VALUE ENGINEERING REPORT

SR 27.US 280 Widening and Reconstruction
SR 45 in Plains to SR 49 South of Americus
STP-030-1(18)
Sumter County

March 19, 2008

ALIGNMENT SHIFT NEAR STA 310+00

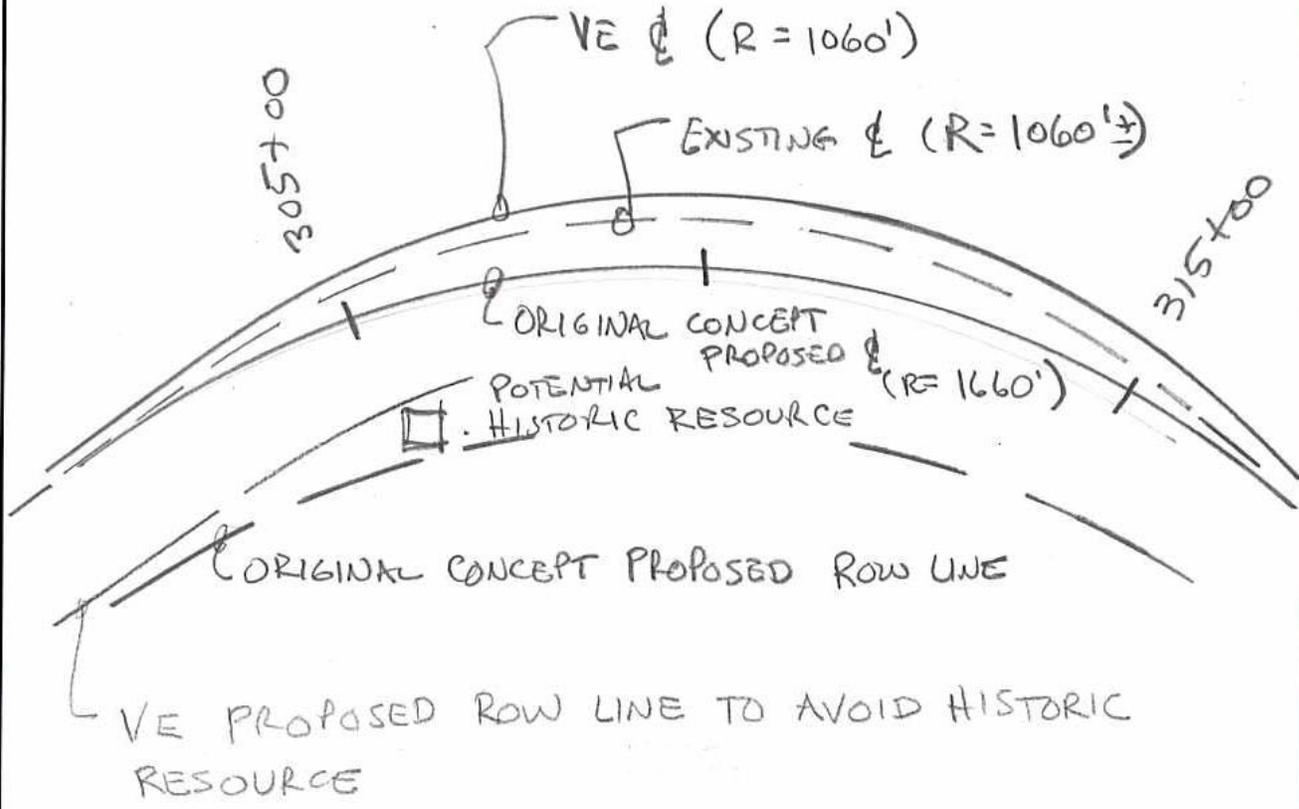
The existing roadway horizontal alignment currently meets the criteria for 55 mph. Providing a 65 mph design speed would require reconstruction of the curve at approximate station 310+00 to provide for the larger radius required by the faster design speed. Reconstruction of the curve to meet 65 mph standards results in two displacements, one of which is shown as a potential historic structure. Reducing the design speed to 55 mph in this area, along with a minor alignment shift to the north, would allow utilization of the existing pavement as well as avoiding or minimizing impacts to the potential historic resource.

Cost reductions consist of elimination of alignment shift in vicinity of the Nathan Revell property at Sta 310+00, and retention of existing profile in most areas. This would also result in reduction of required right of way in the vicinity of Station 310+00, and reduction in earthwork at various places throughout the project. In addition, this change should also result in avoiding two displacements on the Nathan Revell property. Without detailed profile for Alternate 2 cost savings cannot be quantified.

The VE Recommendation is a design speed of 55 mph for the portion of the project with a grass median, retaining a 45 mph design speed for the sections at each end as shown in the original concept.

SKETCH	
Project Name: SR 27/US 280 Widening and Reconstruction	IDEA No: P6
	Sheet 2 of 4

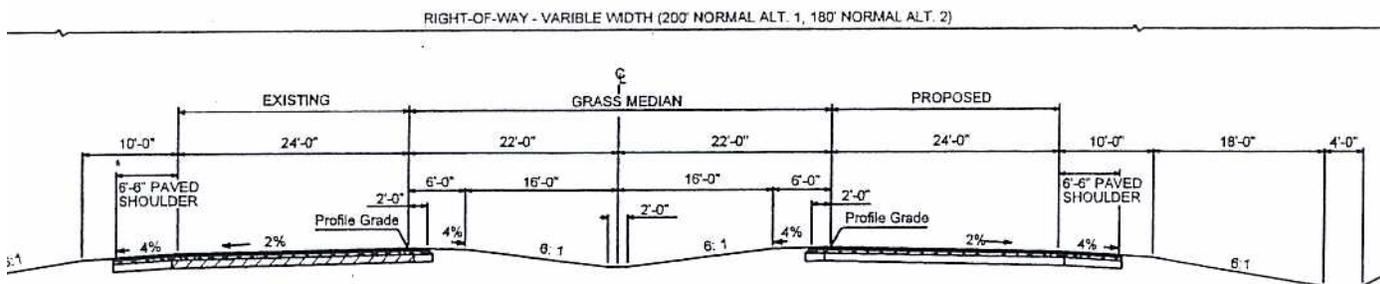
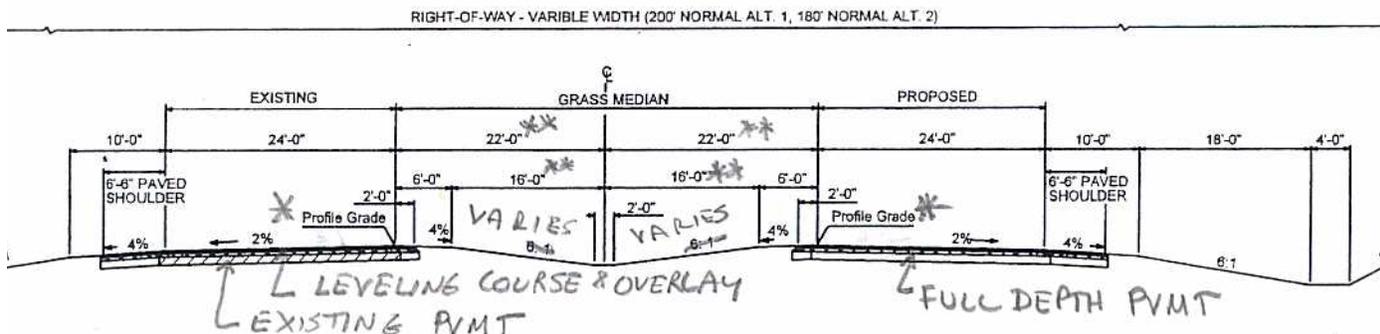
Proposed Change: The VE team proposes construction of only one bound between Sta. 91+75 – Sta. 197+000 and Sta. 266+00 – Sta. 418+00 and leveling & overlaying the existing road as necessary in those locations. The VE team also recommends using 32' depressed median instead of 44' depressed median in creative idea R2. The savings for the reduction in the median width have not been included on the below calculations. Savings from creative idea R2 should be added to the below savings to calculate the potential final savings amount.

Justification: The existing pavement on SR27/US280 is assumed to be in fairly good shape since the Need and Purpose of the concept report doesn't state any need to rehabilitate the existing asphalt and there are no known issues at this point. Leaving the existing pavement in place in the portions of the depressed median area noted above, and adding appropriate shoulders and overlaying the roadway results in significant cost savings for the project. The PGL on each bound would be designed separately by using a bifurcated PGL concept.

* USE BIFURCATED PGL.
** REDUCE PER IDEA # R2
VE PROPOSAL

SKETCH	
Project Name: <i>SR27/US280</i>	IDEA No: R2
SR 27/US 280 Widening and Reconstruction	Sheet 2 of <i>5</i>

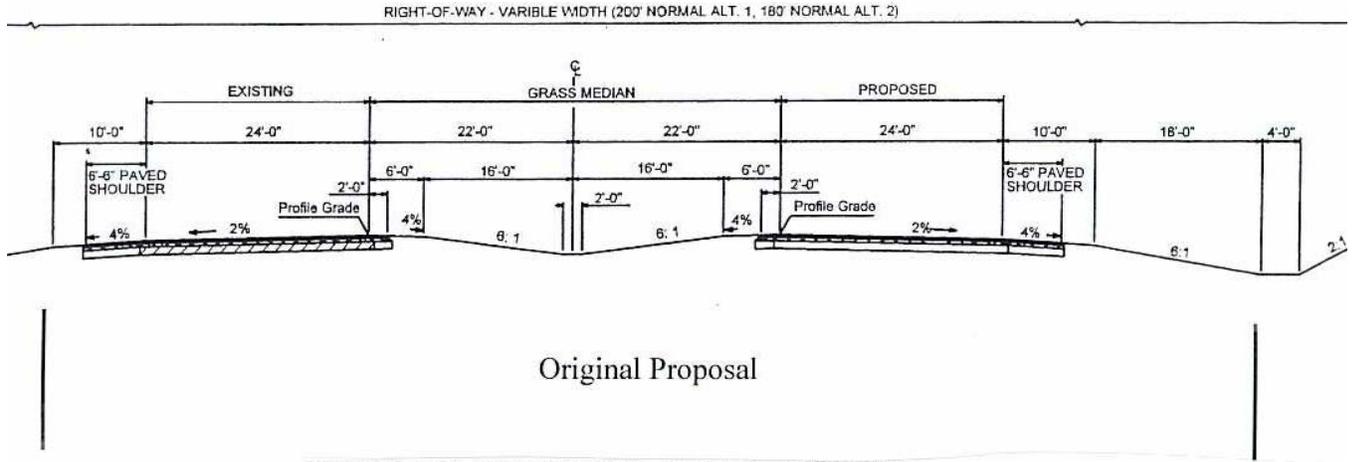
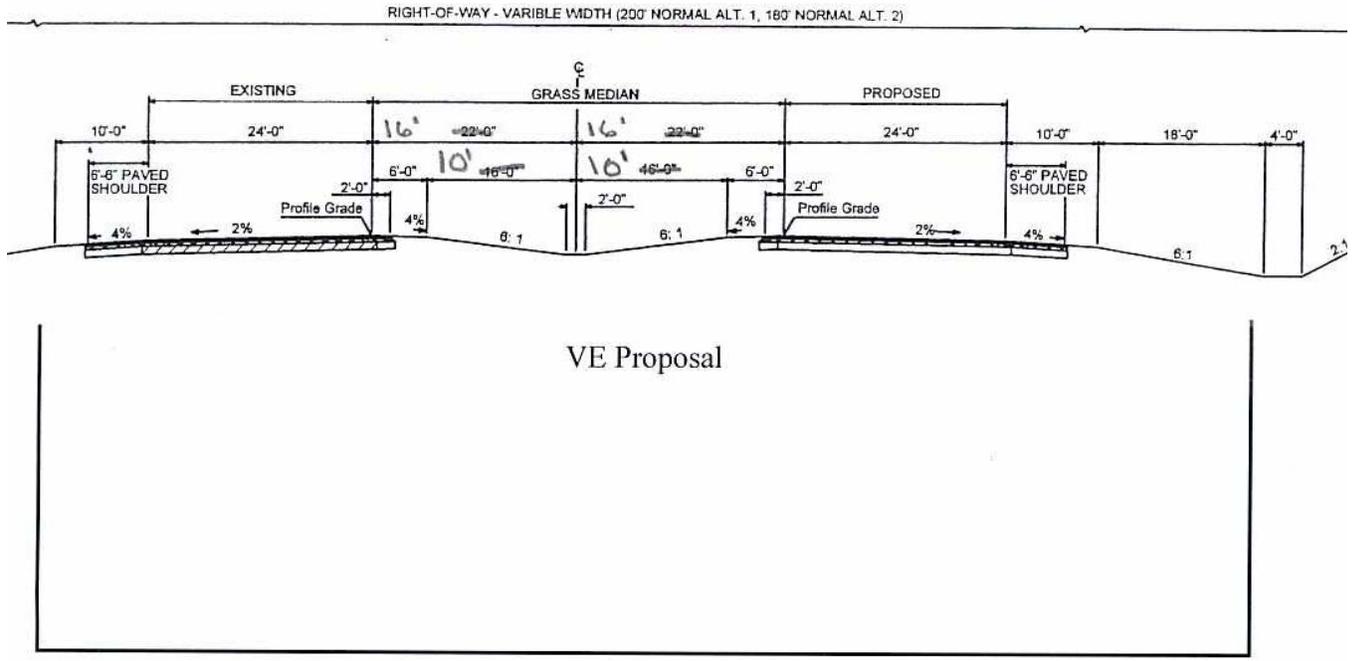
The VE Team recommends a median width of 32' from Sta. 91+75 to Sta. 418+00.

The proposed project is a 4 lane GRIP project with low forecast volumes. Based on anticipated low traffic volumes, reducing the median width would not compromise safety requirements, and could result in significant savings in right of way costs.

Sheet 2 of 3

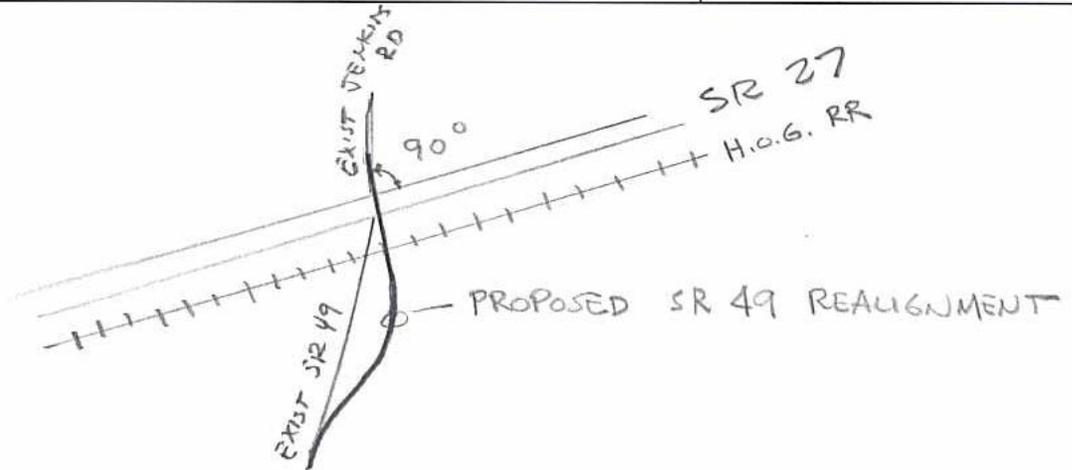
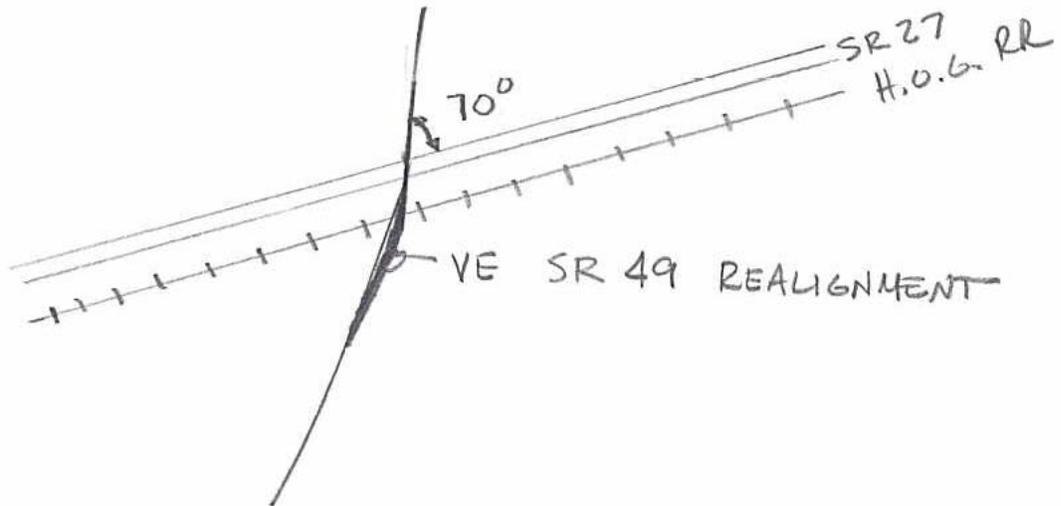
Proposed Change: The VE team proposes to use a 70 degree angle between SR49 South and SR27/US280 so that the proposed alignment of SR49 will be in close proximity of the existing alignment. This would eliminate the proposed improvements outside the proposed right-of-way on Jenkins Road since a 70 degree connection on SR49 South would align properly with the existing Jenkins Road alignment.

Justification: The VE team acknowledges that a perpendicular intersection angle is desirable in a signalized intersection; however, AASHTO allows intersection angles up to 70 degrees. Considering that the majority of the traffic turns right onto SR27/US280 from SR49South northbound, a 70 degree connection would not reduce the safety of this intersection. Also, this would allow reducing the right-of-way impacts and construction cost since the proposed alignment of SR49South would be very close to the existing alignment. This should minimize impacts at the existing grade crossing and also would utilize the maximum amount of existing roadway embankment and right-of-way.
